LOT 10 (NO.115) DIXON ROAD, EAST ROCKINGHAM - SERVICE STATION DEVELOPMENT

Form 1 – Responsible Authority Report (Regulation 12)

REFUSE Development Assessment Panel reference DAP/21/01976 and accompanying plans (Attachment 2):

Revised Site Plan

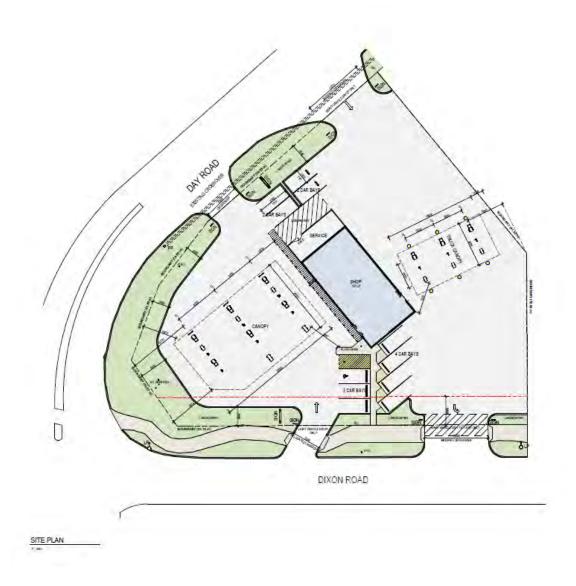
- 1. Traffic generated by the proposed development will adversely impact on the operation of Dixon Road/Day Road intersection, which currently has an unsatisfactory level of service, and will further exacerbate the effect on traffic flow and safety surrounding the site.
- 2. The development fails to provide for sufficient on-site car parking to cater for long term planning of the site. There are also unresolved concerns of the City regarding the functionality of the site plan layout.

- The functional layout of the site plan;
- The impact of the proposed Service Station development on the operation of the Day Road/ Dixon Road intersection adjoining the site to the west;
- A number of the assumptions with traffic modelling contained within the submitted Transport Impact Assessment (TIA); and
- Vegetation classifications and reporting within the Bushfire Management Plan submitted with the application.

- A letter responding to the City's concerns, and providing responses to submissions received:
- Amended development plans;
- A 'Technical note' responding to traffic matters;
- Updated vehicle swept path modelling based on the amended site plan layout;
 and
- An updated Bushfire Management Plan.
